SCANIA Provided Emails and Documents

AMI 01 - 057

## DI16M Limited access to correct spare parts! Turbo lubrication pipe and turbo insulation (port side)

### Overview of the new designed lubrication pipes.

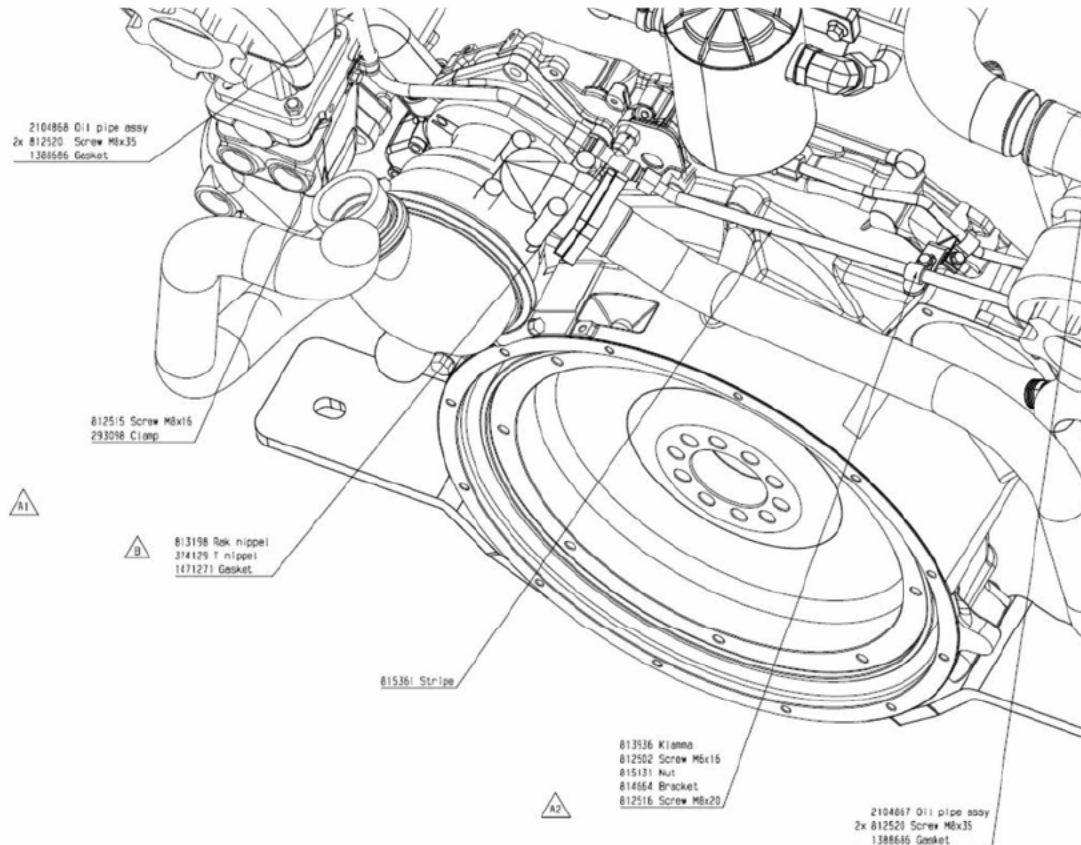
Redesign of the oil pressure hoses was done in the beginning of 2011, however, the new design did not manage normal engine vibrations and did in some cases start to leak after only a few running hours.

New turbo lubrication pipes and port side turbo isolation have been introduced.

Discontinued	Introduced	Ok Engine number limit
Hose RH 2039135	Pipe RH 2104867	1091711
Hose LH 2039134	Pipe LH 2104868	1091711
isolation <b>only</b> LH (Port side) 1548926	Isolation LH 2107533	1091711

### Quick fix solution to fit the old turbo insulation with new pipe.

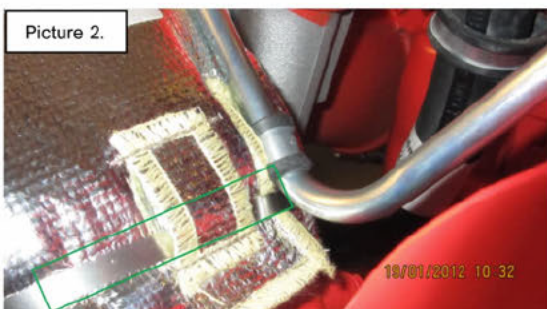
Cut the insulation, (pic1) and secure with new tie raps, (pic2).
